Malfunction Coatron A6Plus: Blocking cuvettes

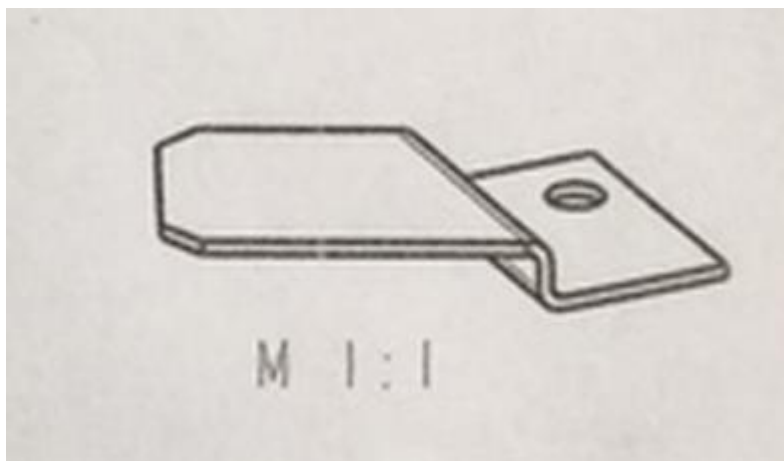
Error description

After measurement the used cuvette is blocking at output position and is not wasted into container. Afterwards the cuvette must be removed manually to continue system operation.

Corrective Actions:

Installation of new part

CAT = 21 023 05 Cuvette output rail

Since Jun-2017 the part is installed on all new Coatron A devices

Coatron A6plus and 5000 with serialnumber xxxx-xxxx-7049 or below must upgrade
